ADDENDUM NO. 2

**South River Fish Passage and
Veterans Memorial Park Improvements Project
Marshfield, MA**

September 11, 2024

Fuss and O'Neill, Inc.
317 Iron Horse Way, Suite 204
Providence, RI 02908

PROJ. No.: 20180319.A23
 DATE: AUGUST 2, 2024
CS-105
 7 OF 21

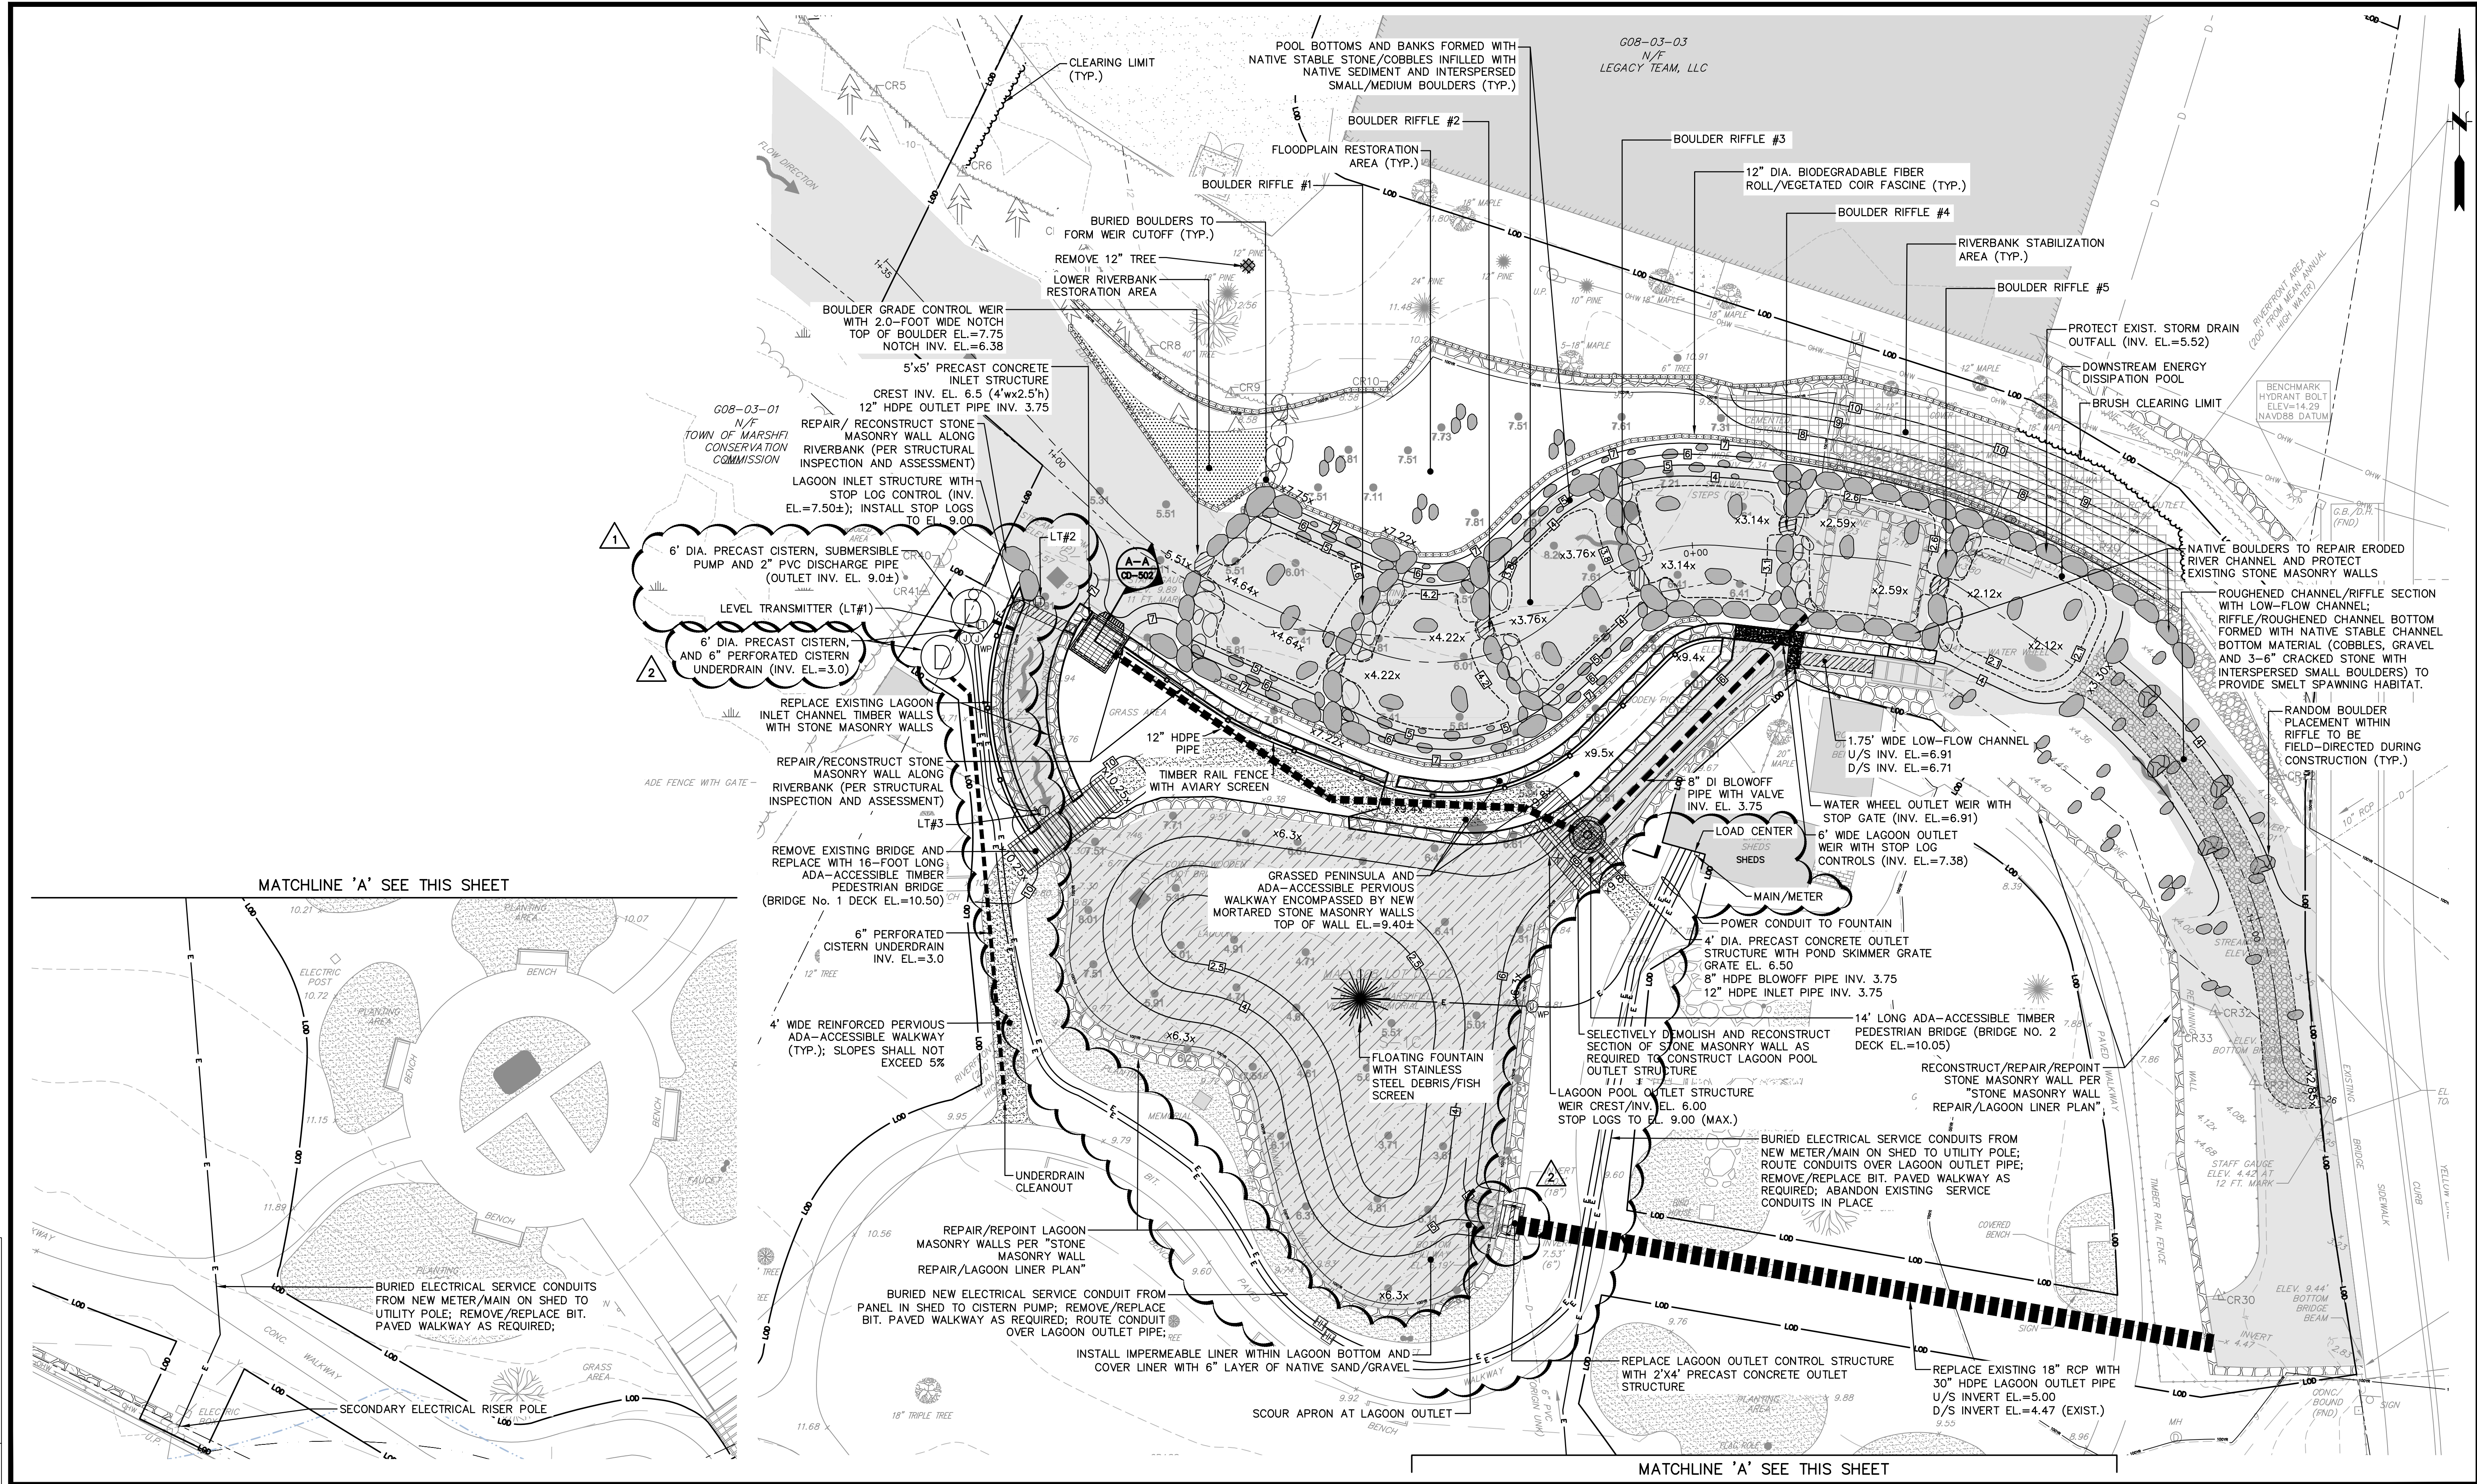
5. Delete Sheets CS-105, CD-502, CD-503, and CD-508 of the Contract Drawings and replace with respective revised sheets provided in Attachment C.
 - A. Sheet CS-105 and CD-502 depict a conversion of the 8” blowoff pipe to ductile iron and a revised lagoon outlet control structure, Sheet CD-503 depicts the addition of a submersible pump detail, and Sheet CD-508 depicts the addition of anticipated pump on/off elevations for the proposed level transmitters (note that these elevations will be reviewed in the field during construction and may be adjusted by the Town).

Please refer to Items 4 and 5 above. Note that there is only one pump called for on Sheets CS-105 and CD-508. Note also that a revision on Sheet CS-105 indicates that the pipe connecting the cisterns is 6" diameter and at EL 3.0.

PRECAST CONCRETE CISTERN
NOT TO SCALE

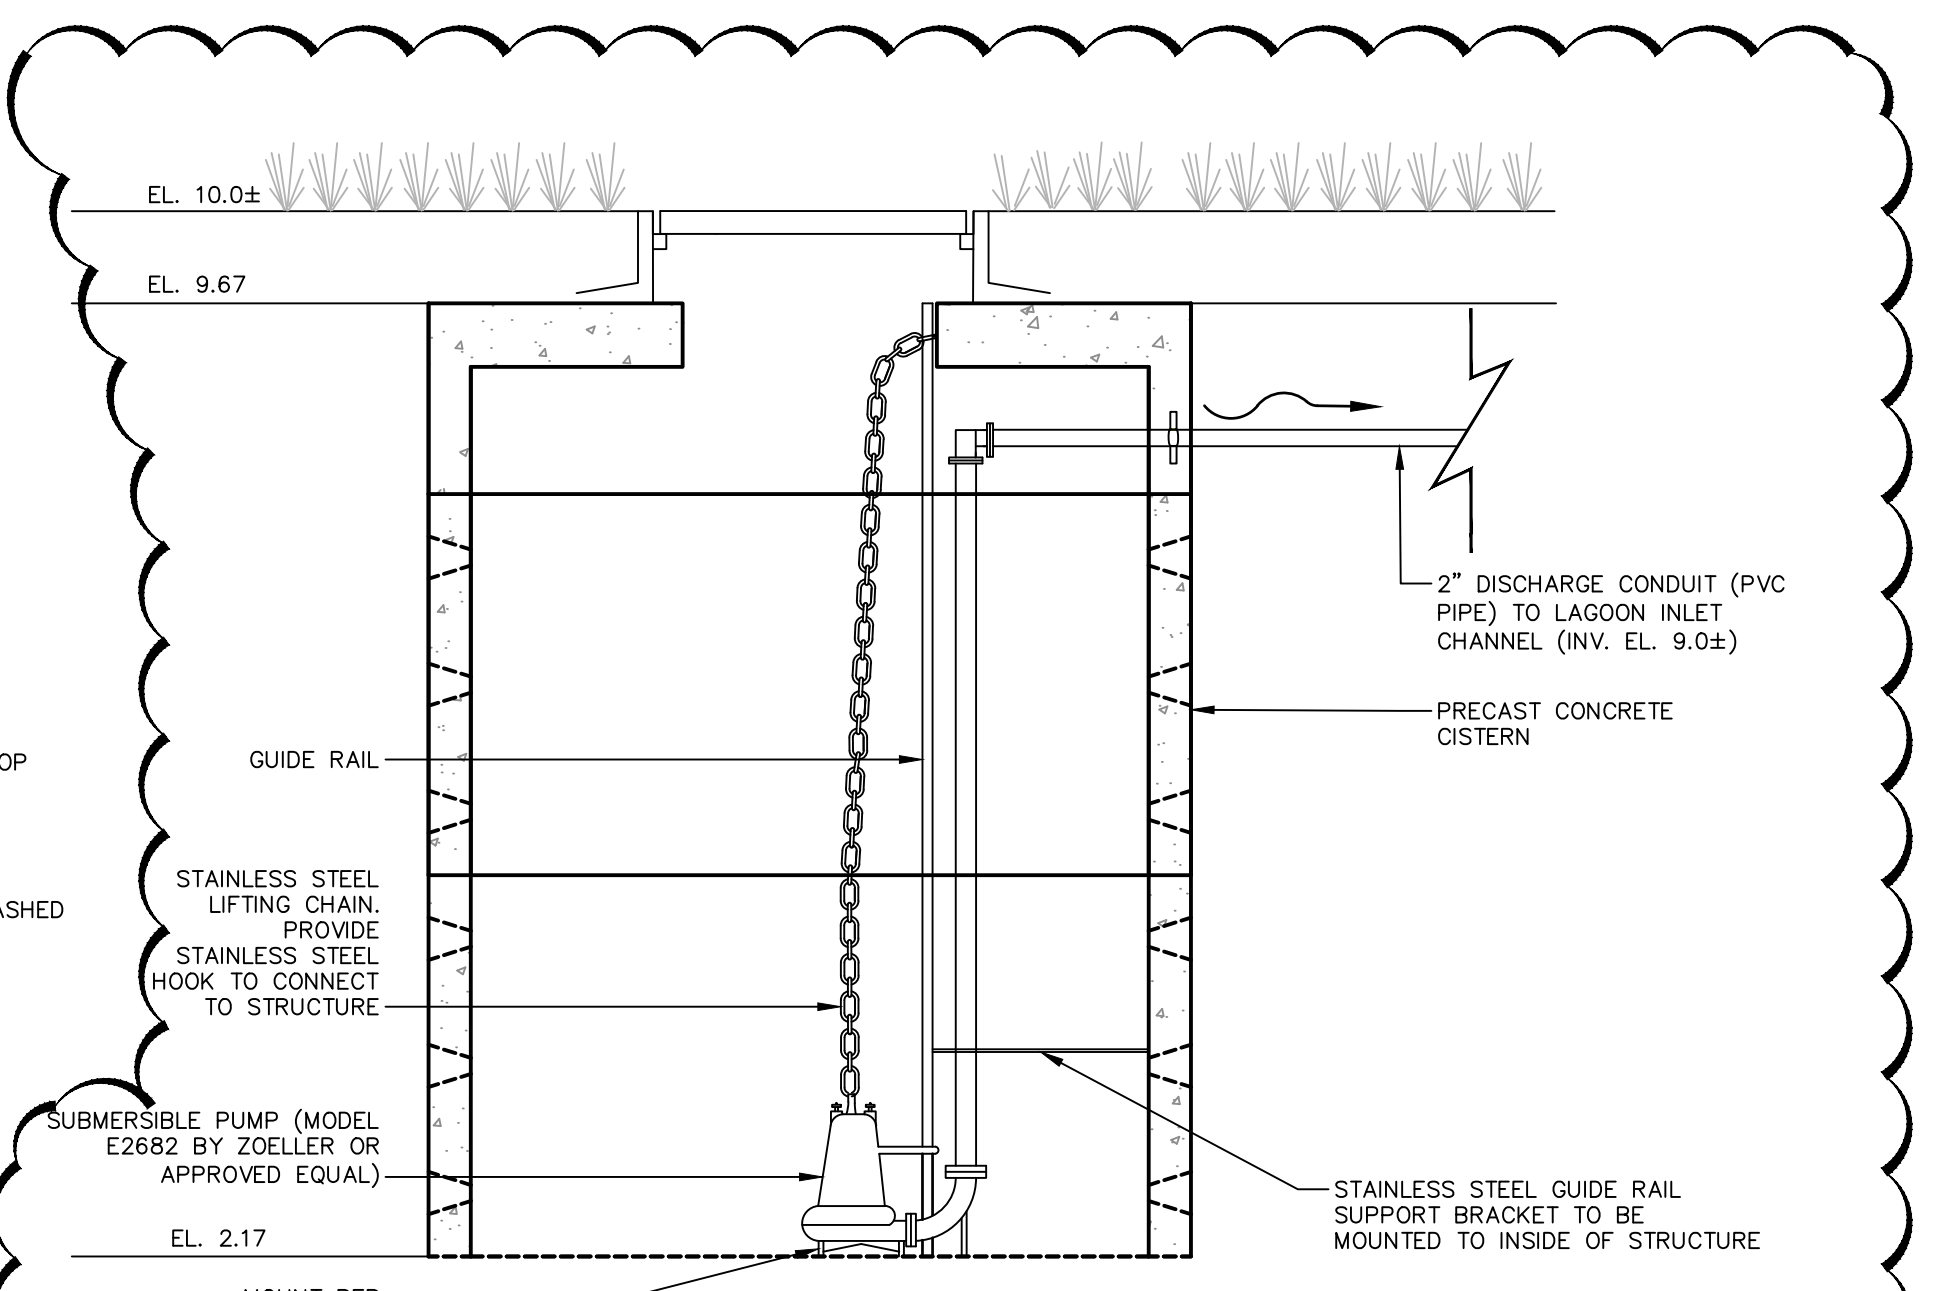
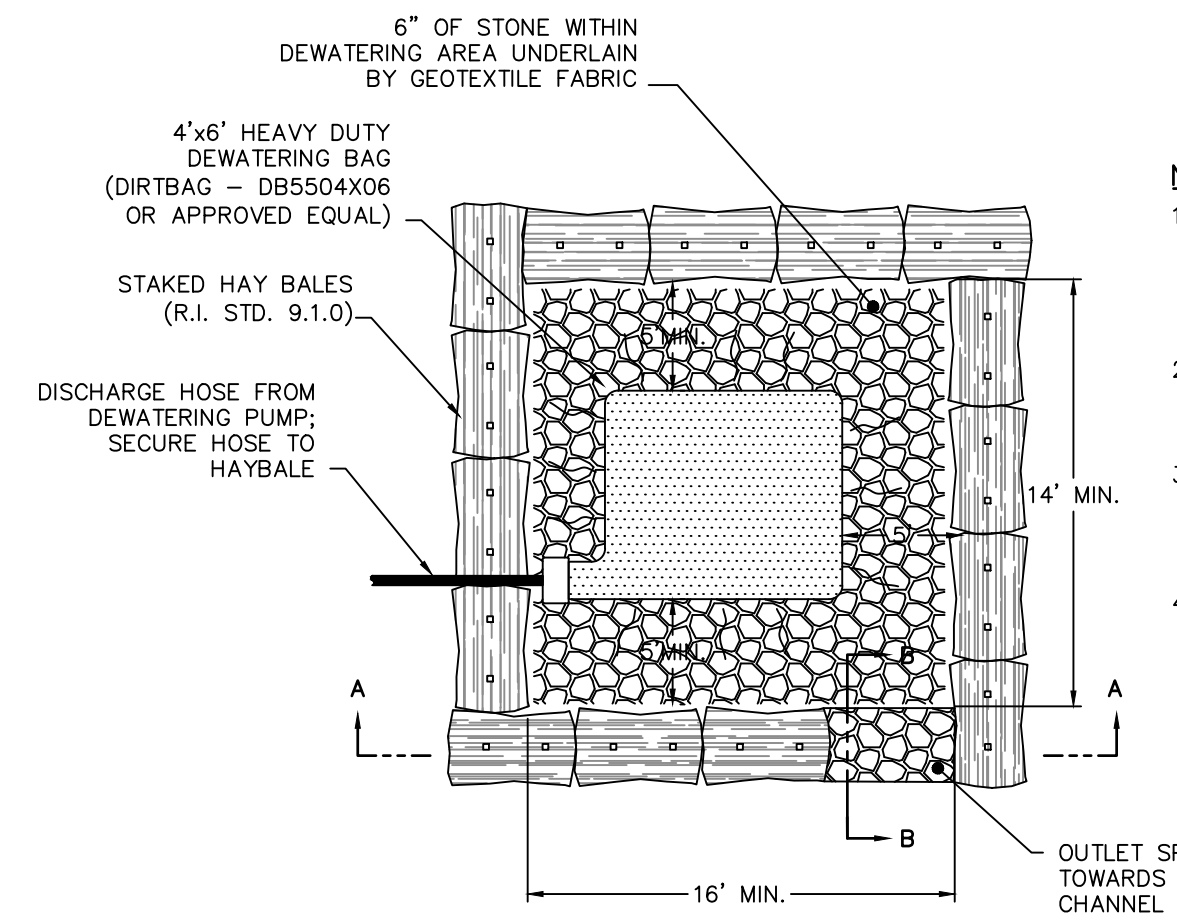
6. Question #1 – There are (2) submersible pumps called out for to be installed on the (2) cistern units but I don't see any specs called out on what type of pumps should be installed – may you provide a submersible pump unit equivalent or let me know if it's in the project solicitation.

BIODEGRADABLE FIBER ROLL
NOT TO SCALE

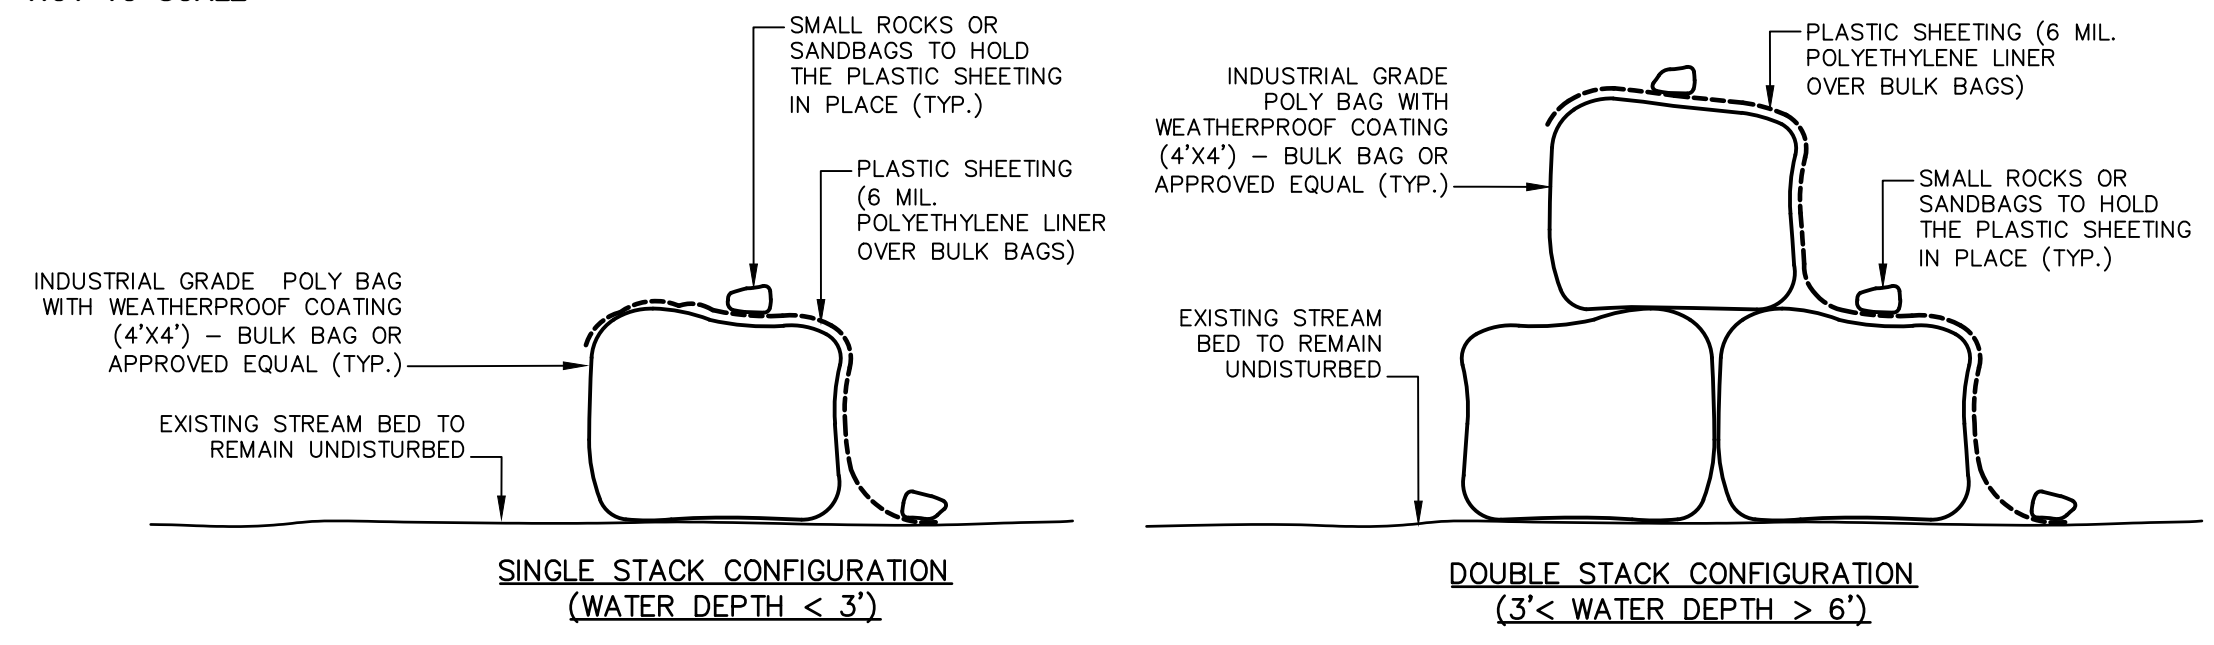
Dredge material transported to this location shall be covered with 10 mil. reinforced poly sheeting and fully enclosed around its perimeter by biodegradable fiber roll (see fiber roll detail on Sheet CD-503) at the end of each working day and at the completion of the project.

The Contractor shall maximize the duration that dredged material is stockpiled/ maintained at the project site to allow the Town of Marshfield to complete preparatory work (survey, clearing, etc.) at the 2160 Ocean Street site before receipt of dredge material. Dredge material stockpiled at the project site shall be covered with 10 mil. reinforced poly sheeting and fully enclosed around its perimeter by biodegradable fiber roll (see fiber roll detail on Sheet CD-503) at the end of each working day.
